PLANNING, ZONING, & BUILDING DEPARTMENT
PZ&B Staff Memorandum: Landmarks Preservation Commission

SUBJECT: HSB-24-0006 210 EL DORADO LN

MEETING: NOVEMBER 20, 2024, LPC

HSB-24-0006 210 EL DORADO LN – Floodplain Variance. The applicant, Gilbert Meister Jr., has filed an application requesting the review and approval of window and door replacement, sunroom renovation, and landscaping and hardscape modifications including a new circular driveway, requiring a variance from the floodplain requirement from Chapter 50, Floods, to maintain the existing building at a finished floor elevation below current FEMA requirement.

B. PROPOSED FRONT DOOR

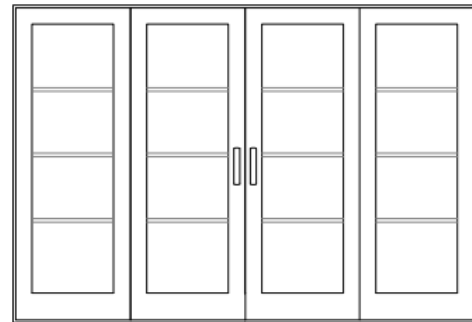
The original front door design features a single door flanked by sidelights on each side with a crisscross design. The existing door configuration features a pair of doors flanked by sidelights with panels and glazing (as shown on page 4). The proposal seeks to restore original configuration (single door flanked by sidelights) with a new design that introduces more glazing on the sidelights:

D. TYPICAL PATIO DOOR
 SCALE: 3/4" = 1'-0"

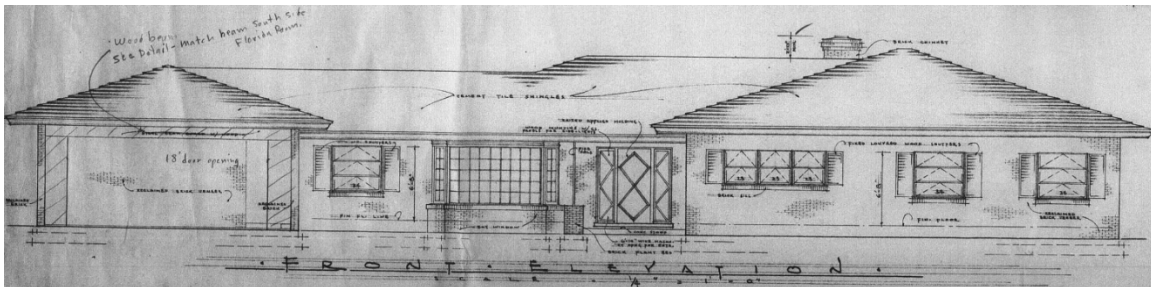
The front (north) and rear (south) facades feature bay windows with divided-light patterns that will be replaced with fixed windows that match the existing divided-light patterns. The scope of work also includes replacement of the existing French doors and sliding glass doors with new French doors with a 4-light horizontal divided-light pattern that were common for masonry residences from this time period. The existing 15-light patterns are not featured in the original architectural plans and do need to be replicated.

Option 1

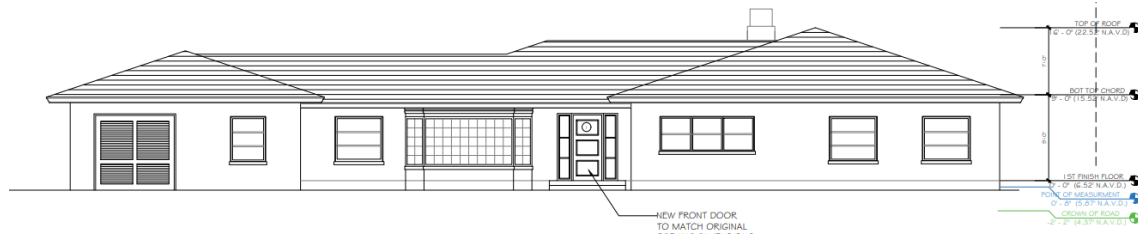
Replicates the original 2-light and 3-light awning window designs with single casement windows and divided-light patterns:

The window schedule provided on sheet 29 indicates the frame color will be white. The louvered shutters are proposed in a blue color. From a historic preservation perspective, option 1 is the most successful if it incorporates shutters as depicted in option 3. Furthermore, windows with a clear-anodized finish frame and clear glazing are recommended based on the original material of the frames and the period of construction.

Option 2

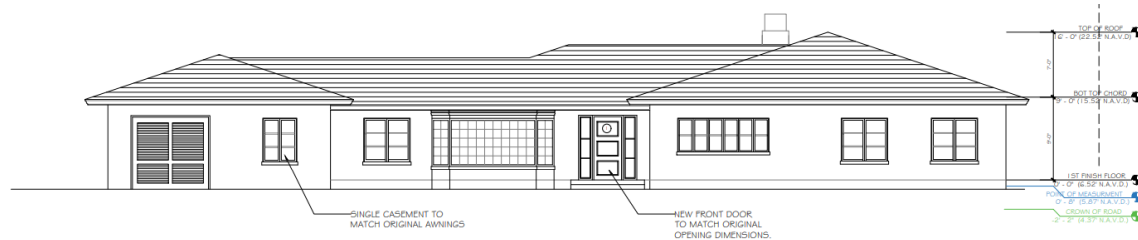
Replicates 3-light and 6-light casement window designs (non-original) with single casement windows and divided-light patterns:

Option 3

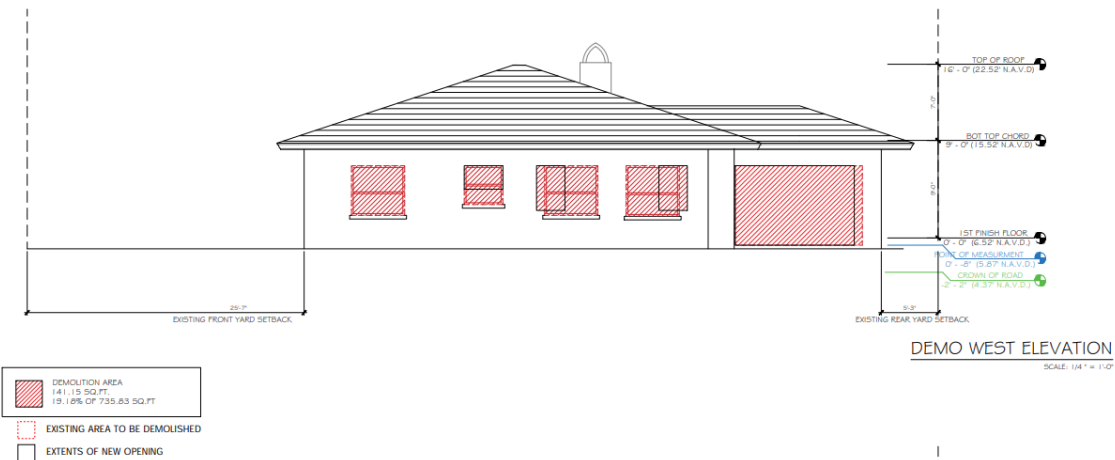
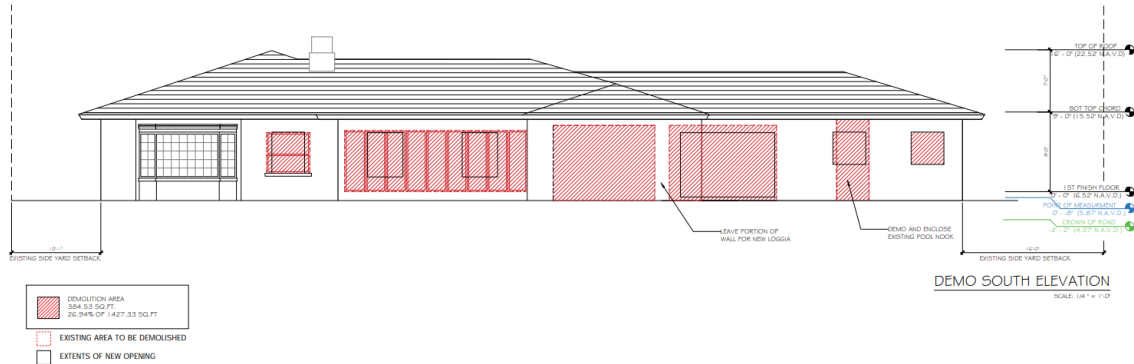
Proposes the same windows as option 2 and incorporates louvered shutters as depicted in the original plans:

Demolition Plan

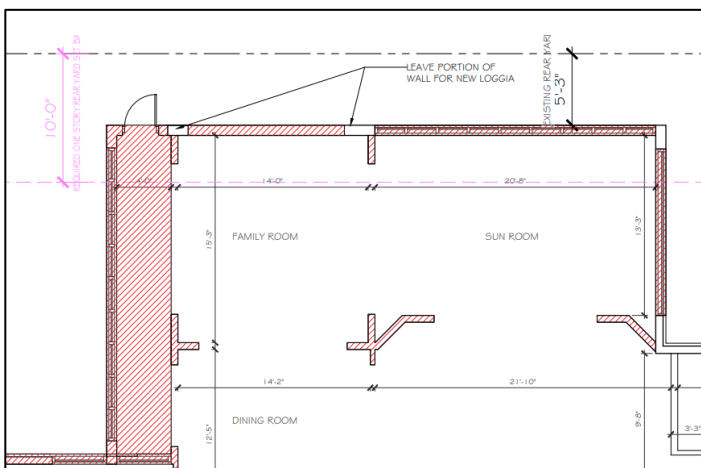
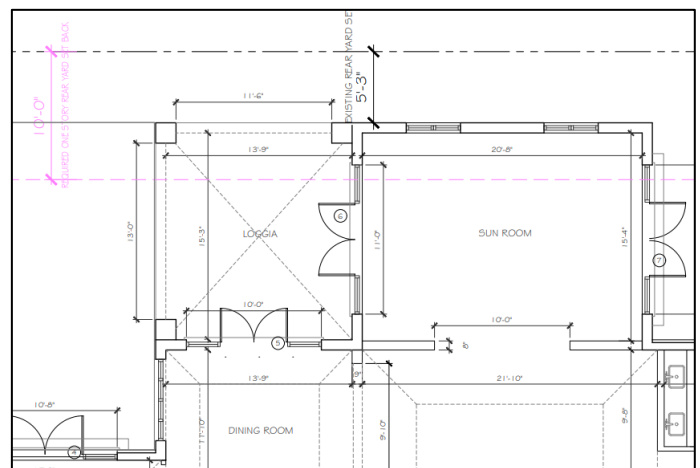
The existing residence has a nonconforming rear yard setback. It abuts Windsor Court to the south. A new loggia will be constructed which decreases the footprint of the building within this area. Two (2) new pairs of 4-light French doors flanked by sidelights with divided-light patterns will be visible from once interior spaces in the residence and one additional set installed facing south closer to the pool.
